Amendments to the Drawings:

REMARKS/ARGUMENTS

This is in response to the office action of July 13, 2005.

Appl. No. 10/771,152
Amdt. Dated October 7, 2005
Reply to Office Action of July 13, 2005

FIG. I PRIOR ART

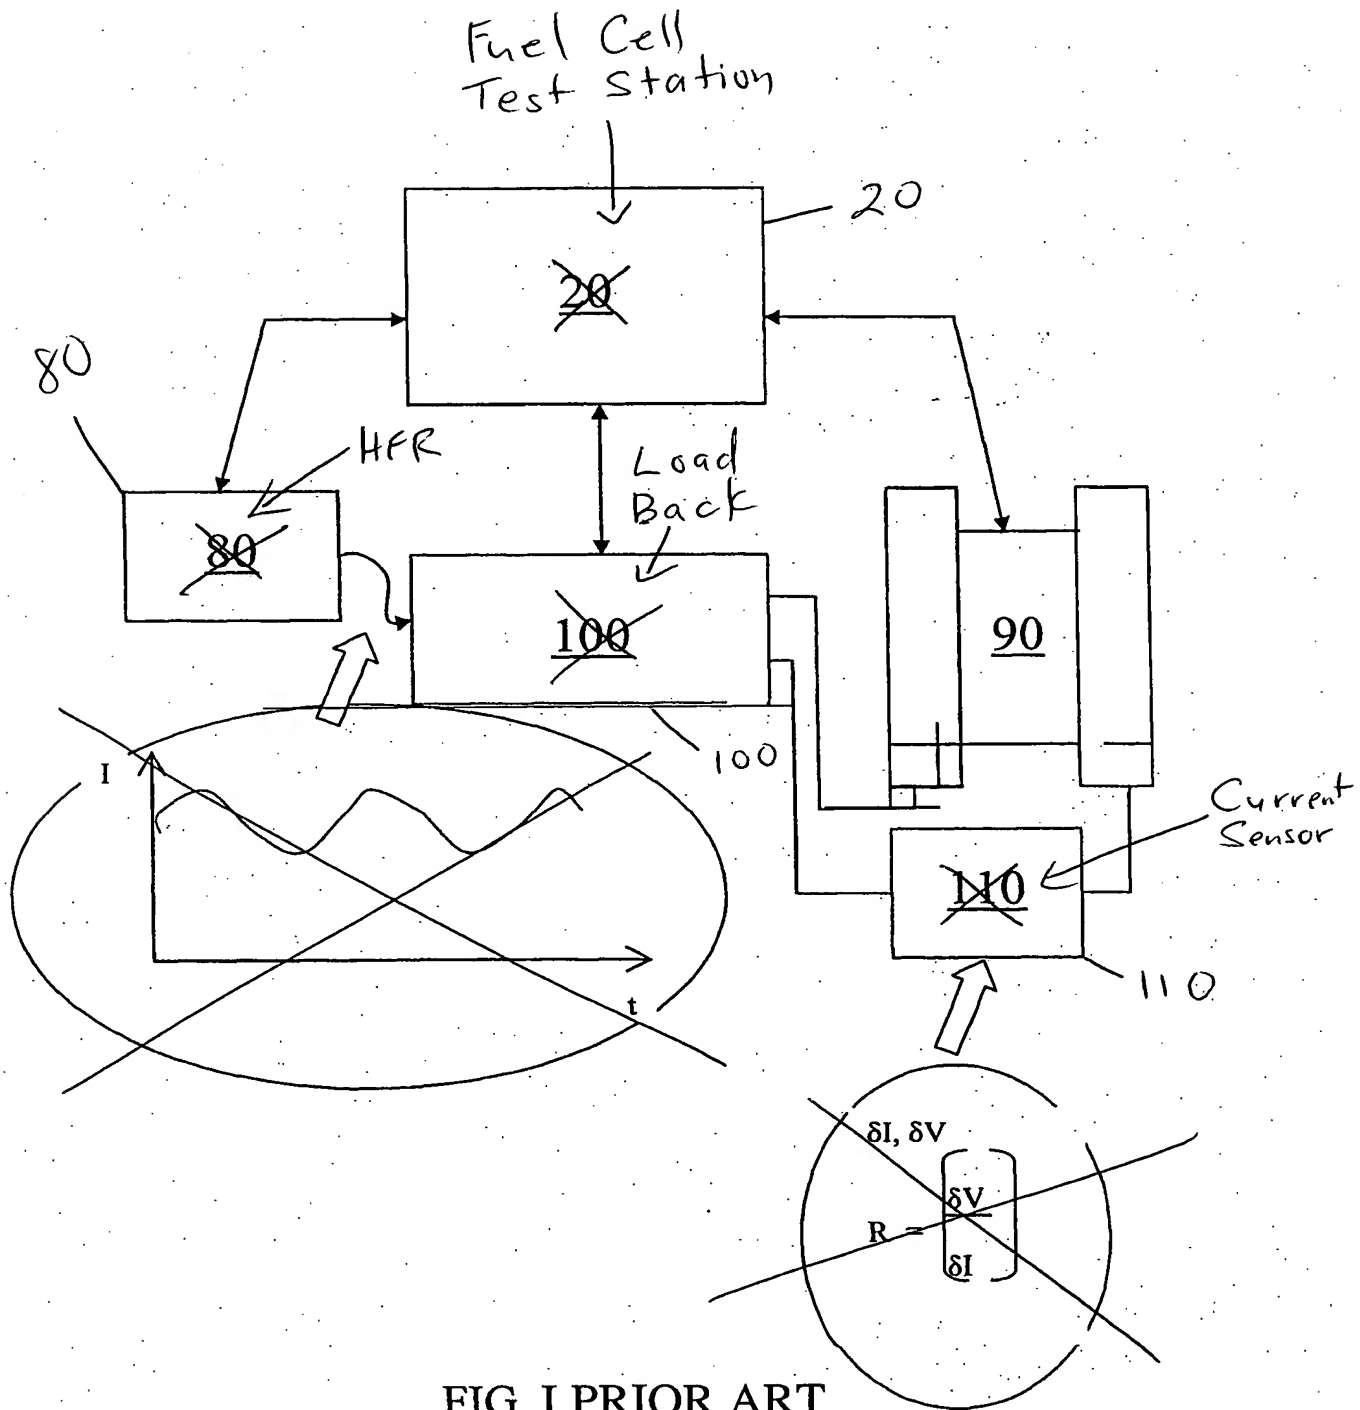
In addition, the Examiner objected to Figure 1 on the basis that it did not include short descriptive labels for the blank boxes.

In response to the Examiner's objections to Figure 1, descriptive labels have been added to the formerly blank boxes of Figure 1. Support for these amendments can be found in paragraph 32 of the specification. In addition, Figure 1 has been amended to remove an equation, and a graph, formerly shown.

FIG. 2a

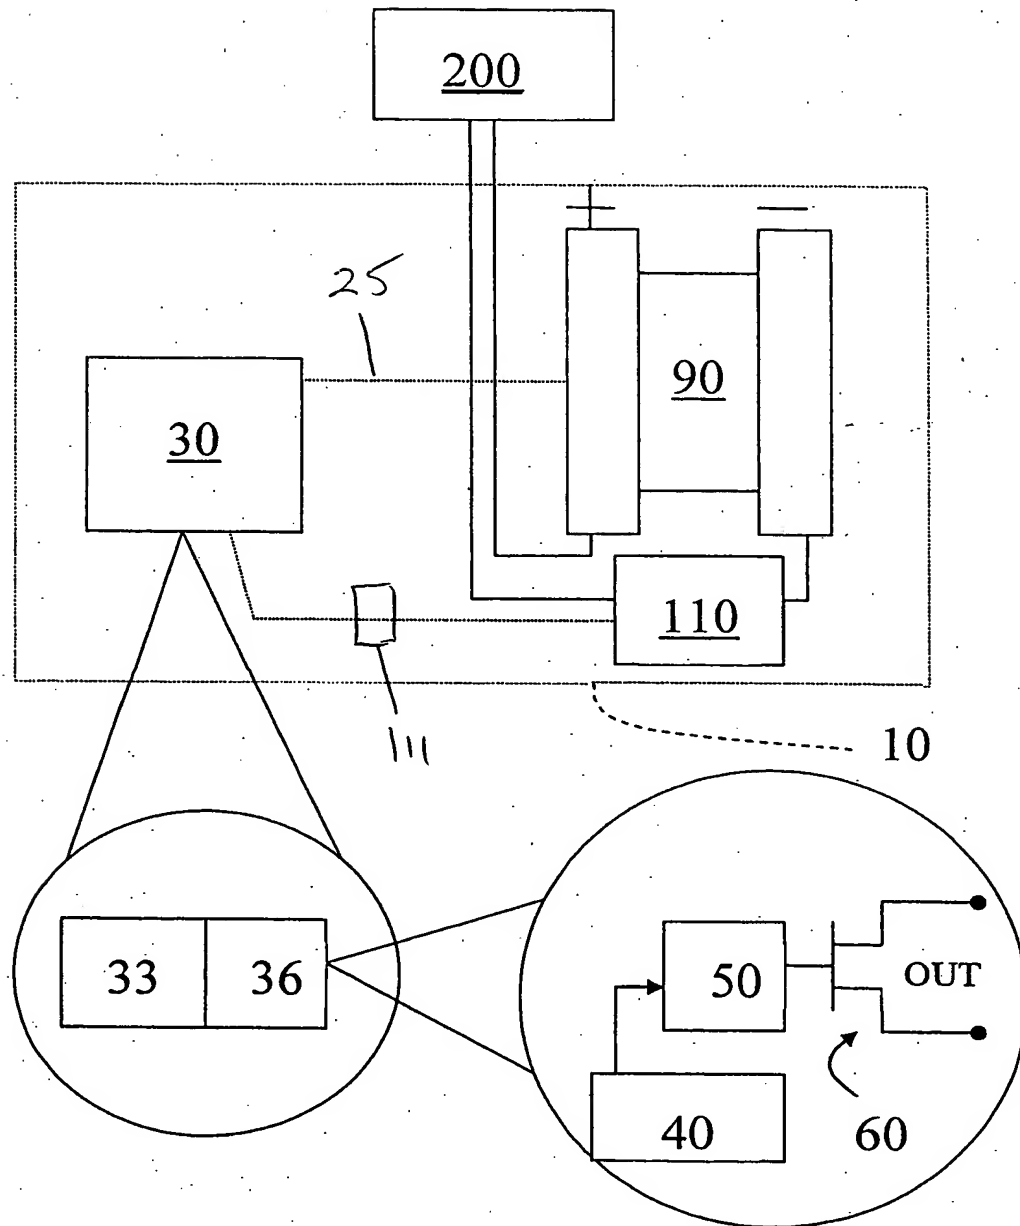
In paragraph 1 of the Office Action, the Examiner took the position that a number of features of the invention as specified in the claims should be added to the drawings. In particular, the Examiner stated that "the plurality of primary channels", "a splitter", "second channels", "a plurality of instrumentation amplifiers", an analog multiplexer", "a first analog to digital converter", "a voltage data bus", "a current amplifier", "an analog and digital control", "a computing device", and "a plurality of differential amplifiers" must be shown in the drawings or, alternatively, such features could be cancelled from the claims.

In response to the Examiner's objections to the drawings for failing to show features of aspects of the invention specified in the claims, Figure 2a has been amended to

show a current amplifier 111. Support for this amendment is provided by paragraphs 36, 45 and 46, which paragraphs have also been amended to include the reference numeral 111 with the term "current amplifier".

In addition to the above-described amendment, Figure 2a, as well as Figure 2b, have both been amended to add reference numeral 25, which designates the plurality of inputs. Support for this amendment is found in paragraph 11 and 35, as well as in claims 1 and 4 of the application as filed. Paragraphs 35 and 43 of the specification have also been amended to include reference numeral 25 to designate the "plurality of inputs".
